Placer County Planning Commission
3091 County Center Drive
Auburn, CA 95603

Subject: August 11, 2016 Item: Proposed Village at Squaw Valley Specific Plan

The Friends of the West Shore (FOWS) appreciates this opportunity to provide comments on the Proposed Village at Squaw Valley Specific Plan (VSVSP), including the final EIR and staff report. FOWS works toward the preservation, protection, and conservation of the West Shore, our watersheds, wildlife, and rural quality of life, for today and future generations, and represents community interests from Emerald Bay to Tahoe City. Although FOWS is concerned with the extensive impacts the VSVSP will have in and around Squaw Valley, our comments focus primarily on impacts that will occur within the Lake Tahoe Basin.

**2013
Area Designations for State
Ambient Air Quality Standards
OZONE**

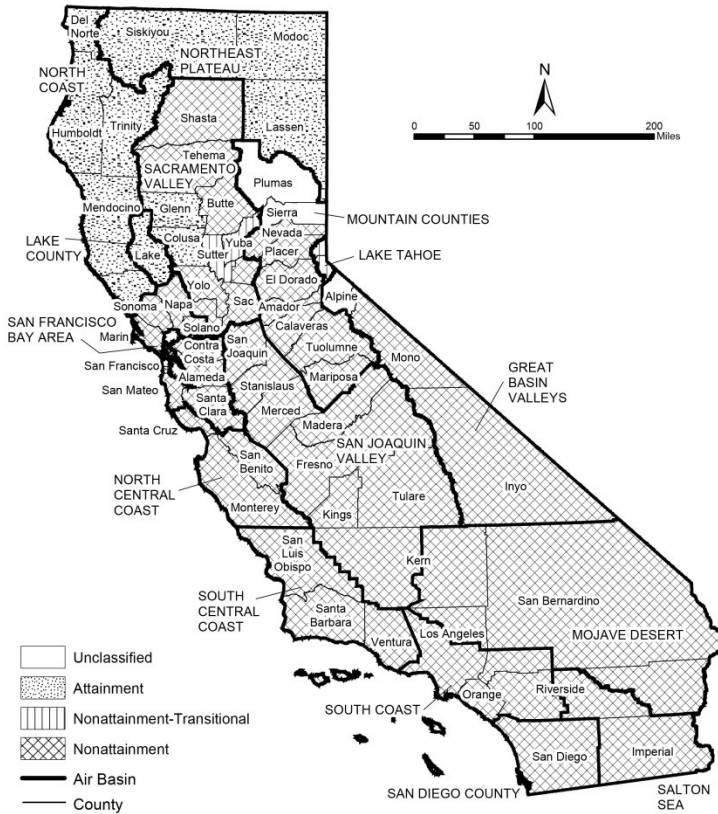
reflected by CARB maps (examples below) clearly delineating the air basins, but also in the CARB's designations for state standards, which clearly indicate individual designations for the Lake Tahoe Air Basin and Mountain Counties Air Basin.¹⁵ It is surprising the document preparers made such an error. In addition, that the TRPA failed to comment on this issue does not negate the public's ability to do so.

The EIR fails to evaluate and disclose the air quality impacts of the proposed project in the Lake Tahoe Air Basin.

Figure 7: Visited Attractions on Trip

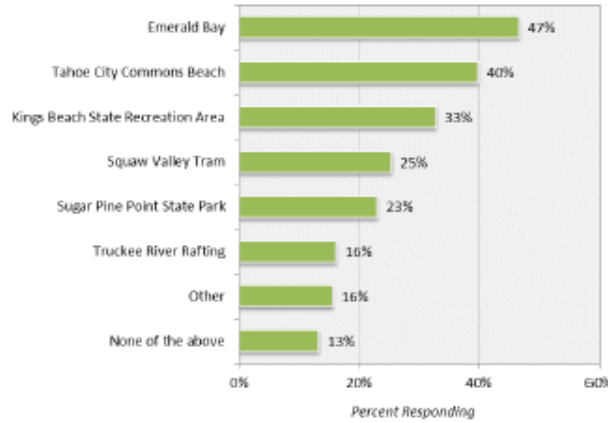
• **Attractions.** Attendance at several different attractions was also queried on the survey. The most popular attraction was Emerald Bay, with 47 percent of survey respondents indicating spending time during their visit there. Somewhat less popular but still important drivers of the visitor experience were Tahoe City Commons Beach (40

percent) and Kings Beach (33 percent). Somewhat less popular were the Squaw Valley tram (25 percent), Sugar Pine Point state park (23 percent), and Truckee River Rafting (16 percent).

The FEIR response refers to the Master Response regarding traffic impacts in the Tahoe Basin, which then fails to respond to the question. The public has not been provided the information used to assess where guests and employees are expected to drive in the Lake Tahoe Basin. Although Appendix C provides estimates of locations and associated VMT, the assumptions used to generate the trip data are still not provided. As noted, the estimated guest trips into the Tahoe Basin, including on SR 89 along the West Shore, appear to significantly underestimate trips based on the information presented in the North Lake Tahoe Resort Association’s 2014 survey of traveler destinations.
